Neill Collins  
Planning Services  
Ealing Council  
Perceval House  
14-16 Uxbridge Road  
Ealing  
W5 2HL

18<sup>th</sup> March 2013

**Planning Application P/2013/0571**  
**Construction of 3 Storey House facing Chandos Avenue**  
**to the rear of 176 South Ealing Road W5 4RJ**

**Existing Chandos Avenue Elevation**

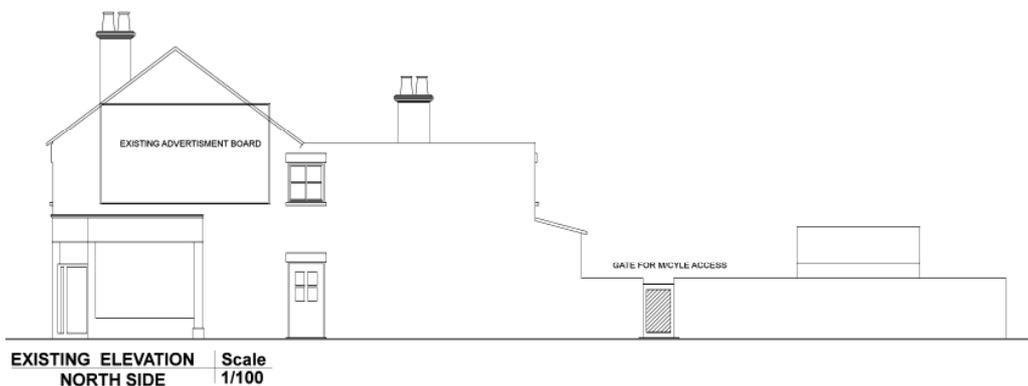
When compared to the following photograph, it will be noted that the location of the corrugated shed is incorrect and that its height has been exaggerated.

It will be noted that the shed is located as far away as possible from 1 & 1A Chandos Avenue and that it barely exceeds the height of the boundary wall. The existing building on the rear yard is therefore far less imposing on Chandos Avenue than implied in the application.

#### **Pizza delivery motorbike parking area**

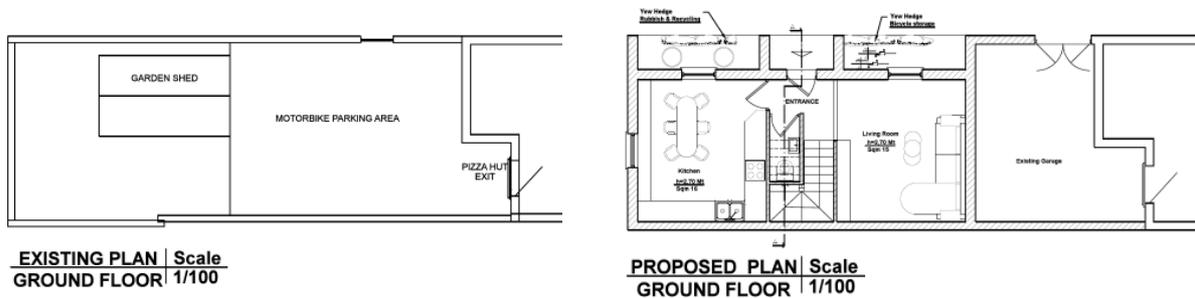
We note that the application includes the roofing over the open yard currently used for the storage of pizza delivery motorbikes.

A significant reduction in the area allocated to motorbike parking appears to be proposed. This needs to be considered along with the deletion of the shed currently used for pizza restaurant storage.

We therefore assume that none of the proposed garage area will be available to provide off-street parking for the residents of the proposed house. If some or all of this area was to be exclusively reserved for parking by the house's residents, we would suggest that this should be recorded by means of a planning condition.

**Shaded Block Plan of site of proposed house**

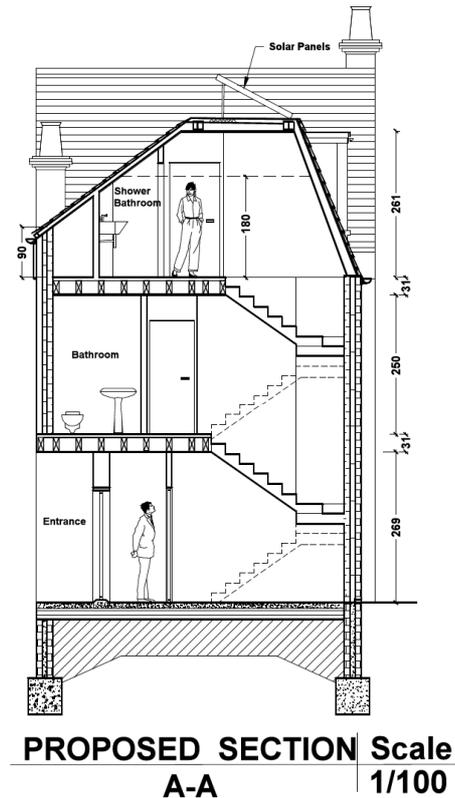
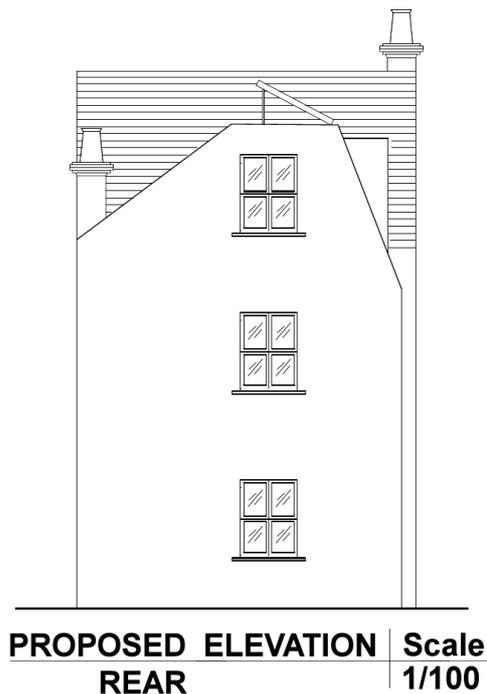
We note that the proposal is to build forward to the pavement edge and significantly forward of the hundred year old, and still intact, Chandos Avenue building line. The relationship of the proposed house to the existing houses in Chandos Avenue is shown by the following shaded block plan.

It appears that the Chandos Avenue building line will align with the central vertical glazing bar of the proposed side windows, and the majority of the proposed building will be forward of the building line.

The exact position of the Chandos Avenue building line would have been clarified if the applicant had chosen to submit a ground floor plan which extended to include 1 & 1A Chandos Avenue.

**4.2 Height of proposed house at pavement edge**

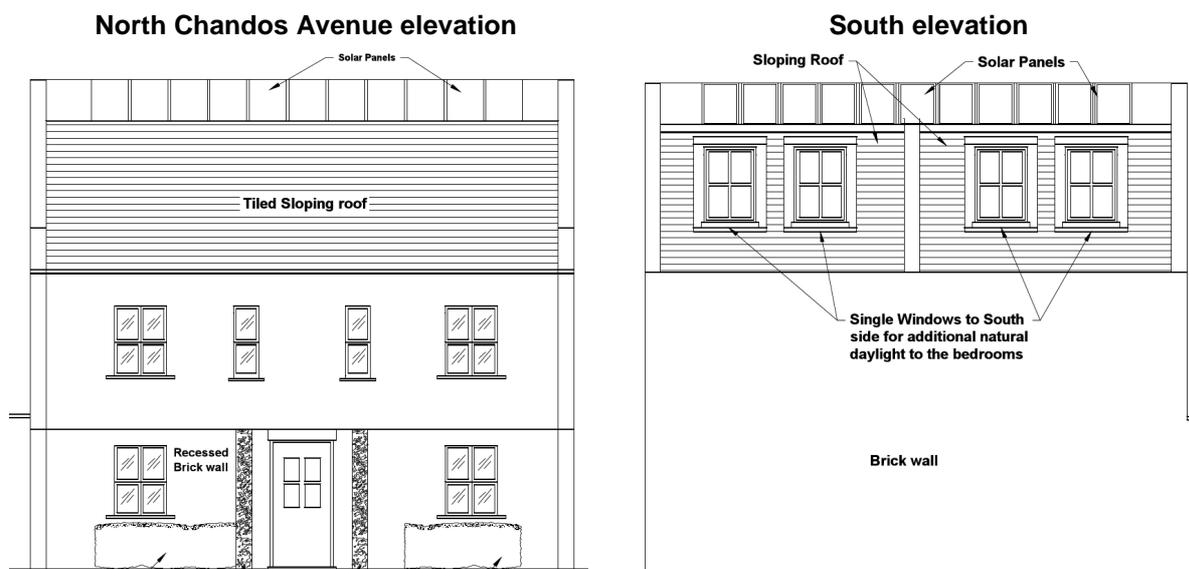
There appears to be an inconsistency in the submitted drawings over the vertical height of the pavement facade.

According to the western 'rear' elevation, reproduced above, the Chandos Avenue facade will be extended vertically by 90 centimetres above the second floor level. It will be seen from the above extracts that the eaves of the front of the building facing Chandos Avenue (north elevation) are above the height of the eaves facing the rear yard of 178 South Ealing Road (south elevation).

Unfortunately, this differential in eaves height is not evidenced on the scale drawings of the north and south elevations. Both of which show the roof slope starting at second floor height.

We therefore suggest that the Chandos Avenue (north) elevation is misleading in that it fails to include the vertical extension of the front facade above second floor level.

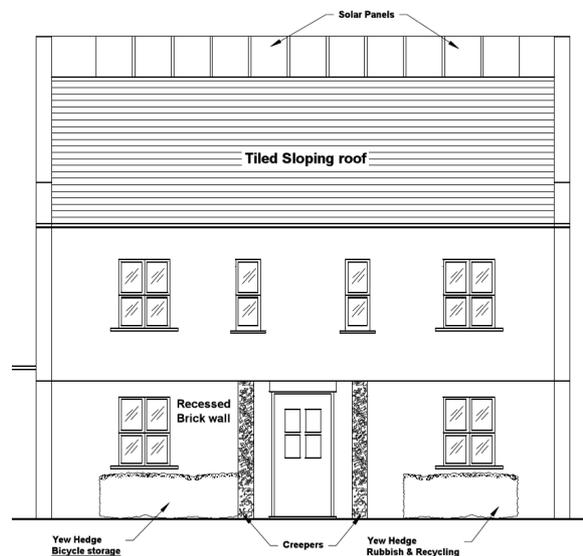
It has been pointed out to us that the front eaves height and the roof height of the proposed house are likely to be above those of the neighbouring Edwardian terrace ending at 1 & 1A Chandos Avenue. This increase from two to three storeys would equate to a fifty percent increase in height at the established building line.

We believe this should be checked and regret the decision of the applicant to fail to submit scaled floor plans and elevations which included 1 & 1A Chandos Avenue.

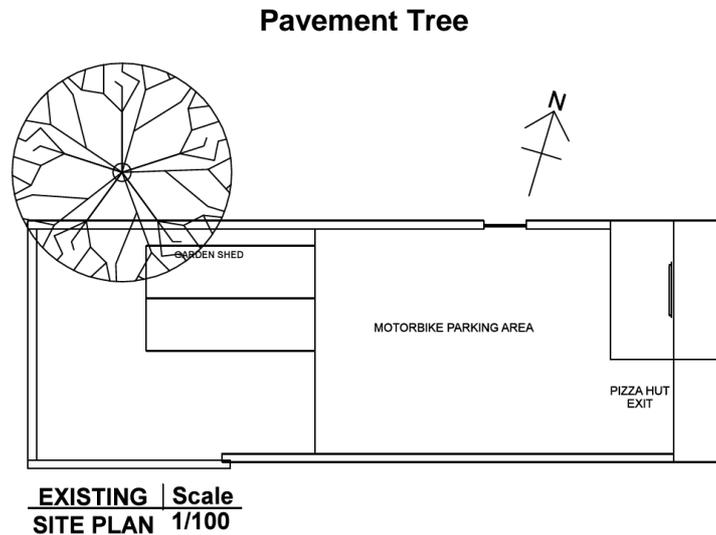
The 'existing' plans record the existence of a tree at the pavement edge in front of the proposed house.

The location of the tree appears to have been recorded on the drawing as too far to the west and shows an insufficient canopy, when compared to the following Google aerial photo. The location of the tree is also shown in the photograph in section 3.2 above.

We are concerned that there is no reference to the tree in the 'proposed' floor plans or elevations. Nor can we locate any mention of the pavement tree in the Design and Access Statement.

The implication is that this mature tree will be felled.

Mature pavement trees are an integral and highly valued component of the local character of our neighbourhood. We therefore urge the Council to ensure that this tree is retained.

## Inconsistency as to existence of First Floor south facing windows

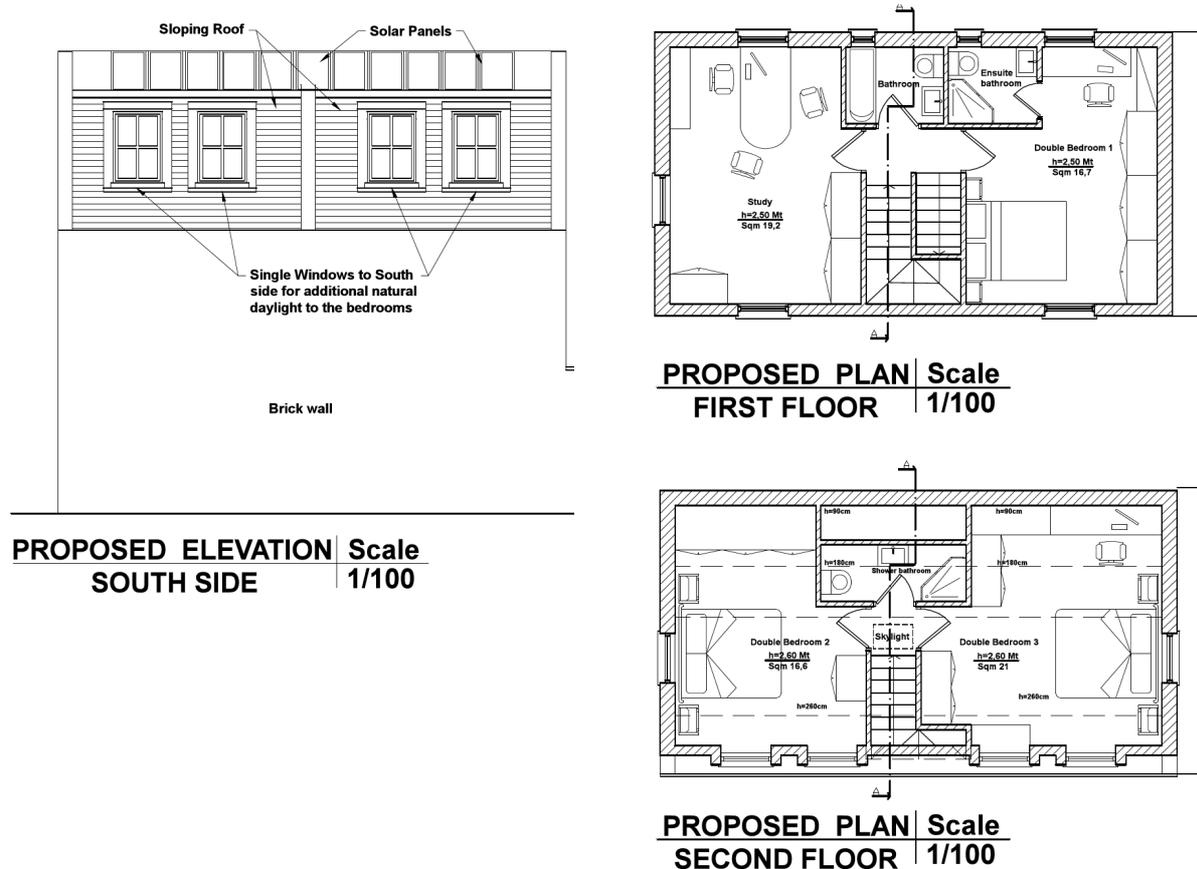
We also draw your attention to an apparent inconsistency between the windows shown on the proposed elevations and proposed floor plans.

The south elevation shown in the extract below only contains overlooking windows on the boundary line at second floor level, while the floor plans show south facing windows at both first and second floor level.

We ask you to review the location of all windows and to consider implementing a planning condition requiring them to be both obscure glazed and non-opening where this would be appropriate, to protect the amenity of both the surrounding residents and/or the occupiers of the proposed development.
